## Technical Guidance Committee Meeting

Thursday February 4, 2016

# Technical Guidance Committee Meeting

## Draft Minutes

Figure 4-46. Cross-sectional view of a subsurface flow constructed wetland.

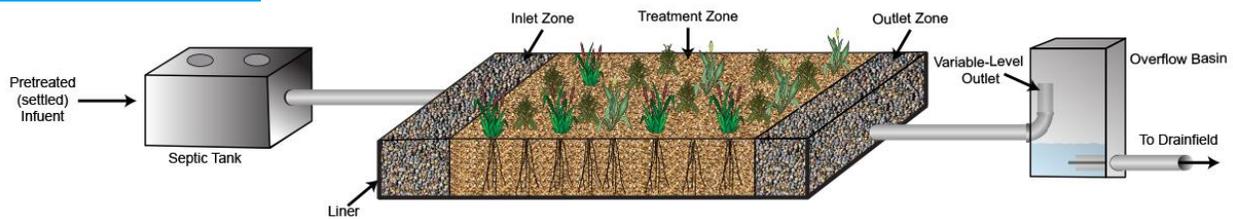
**Action Item:** Move the arrow in Figure 4-46 identifying the liner location.

Figure 4-3031. Bottom view of a mechanical flow splitter for gravity distribution that delivers wastewater to all transport pipes with each dose.

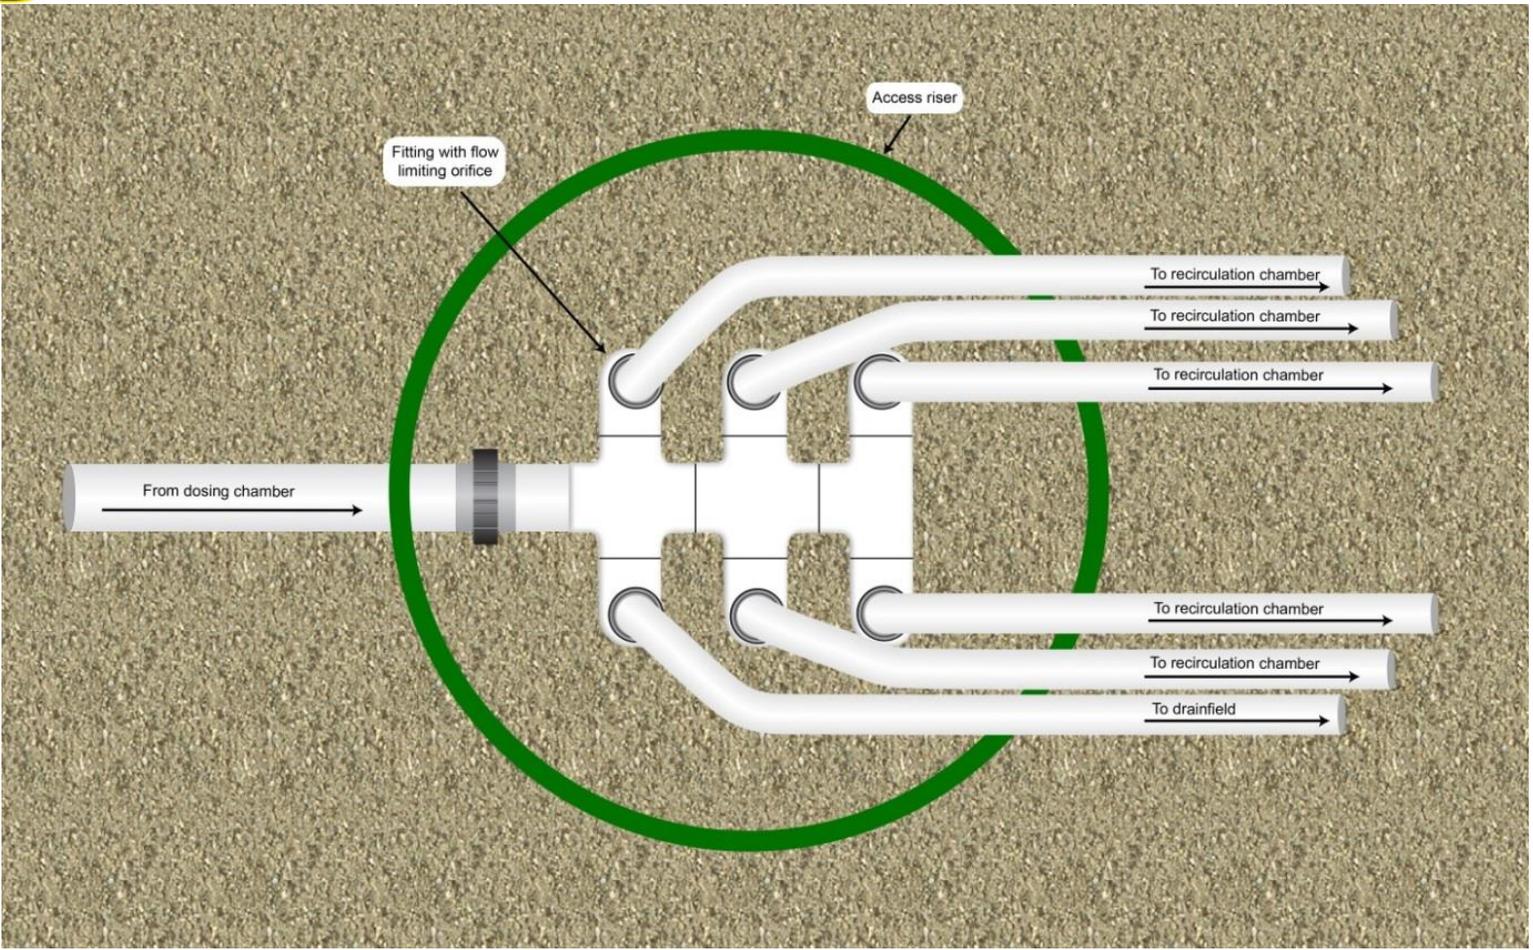
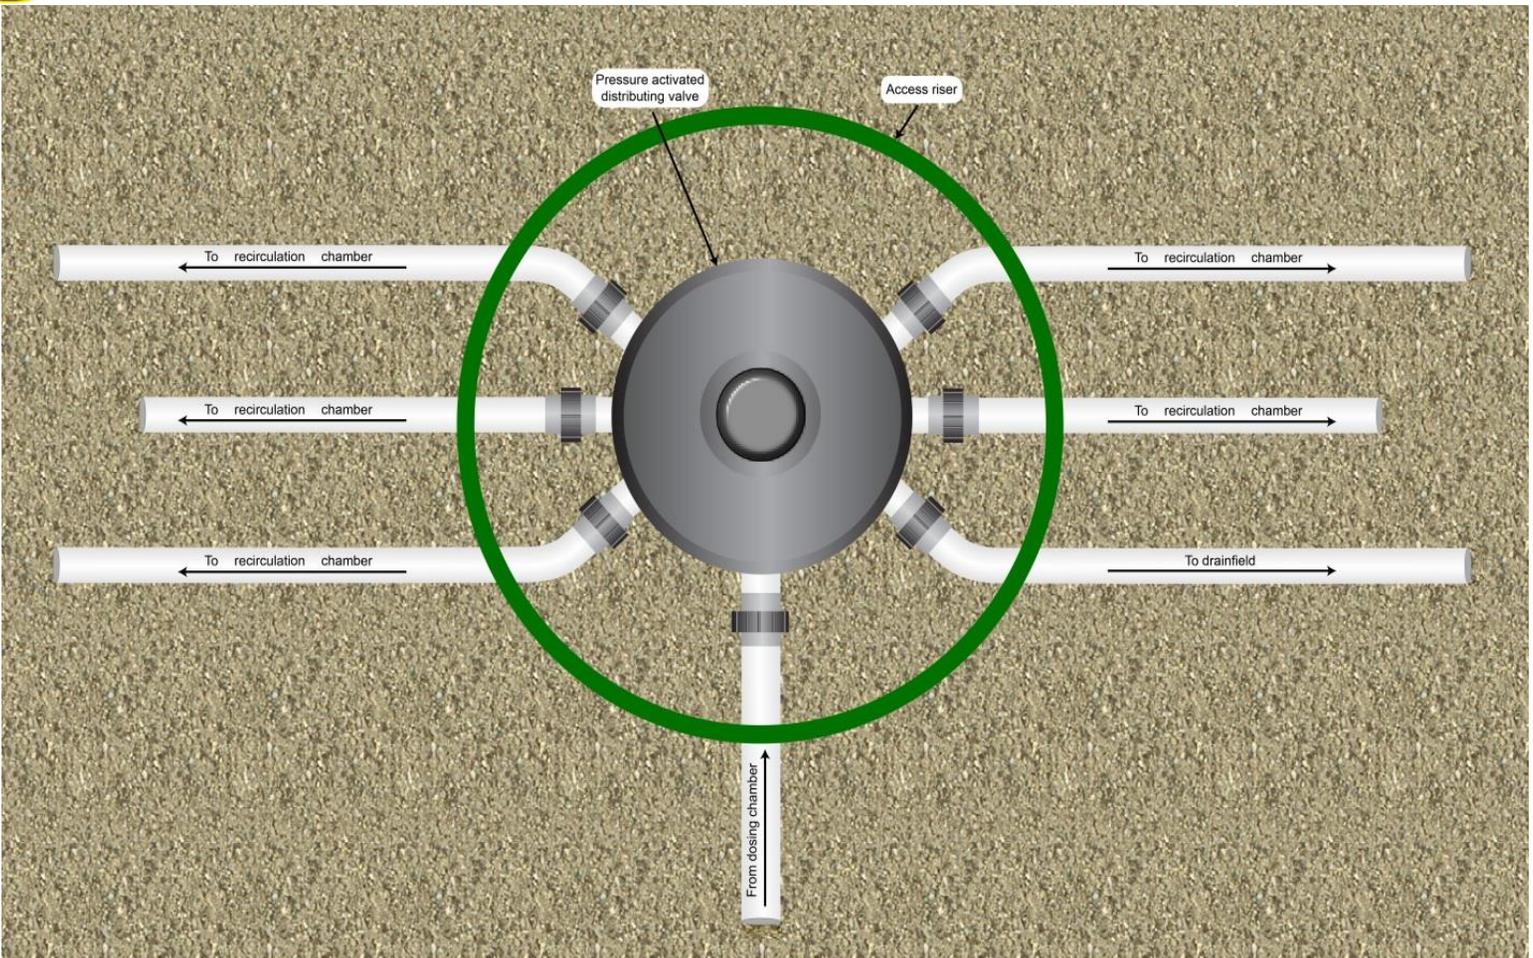
- ~~2. A mechanical flow splitter (Figure 4-30~~31~~ and Figure 4-31~~32~~) capable of simultaneously returning effluent to the recirculating tank and discharging effluent to the drainfield shall be located outside of the dosing chamber and before the recirculation tank. The flow splitter shall meet the following minimum requirements:~~

- b. Utilize a mechanical flow splitter (Figure 4-31 and Figure 4-32) that is capable of simultaneously returning effluent to the recirculating tank and discharging effluent to the drainfield.
